AMENDMENTS TO THE DRAWINGS

REMARKS

Fig. 1

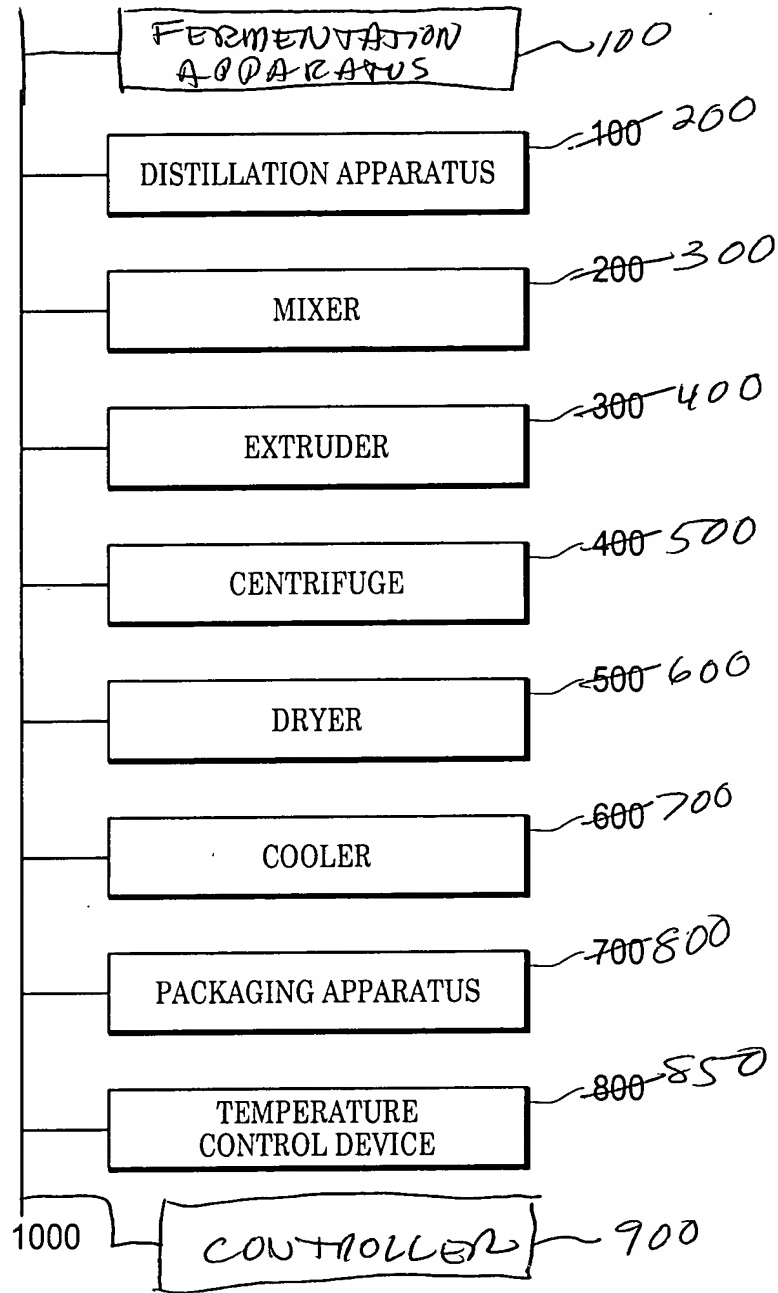
The Examiner has objected to the drawings because they do not show “controller 900,” and because the reference numbers in paragraph 30 do not correspond with the element labels in Fig. 1.

Fig. 1 has been amended to show the system elements described in paragraph [0028] of the main body of the specification.

In order to overcome this objection, Applicants are concurrently submitting Proposed Drawing Corrections for the Examiner’s approval, which amends Fig. 1 to illustrate controller 900. Applicants have also amended Fig. 1 by re-labeling the temperature controller, and have provided a numerical label to the temperature control device in both Fig. 1 and in the main body of the specification to fully comply with MPEP §608.02(d).

Applicants have also amended Fig. 1 to illustrate “[E]lements 100 through 900 . . .” as described in paragraph [0028] of the main body of the specification.
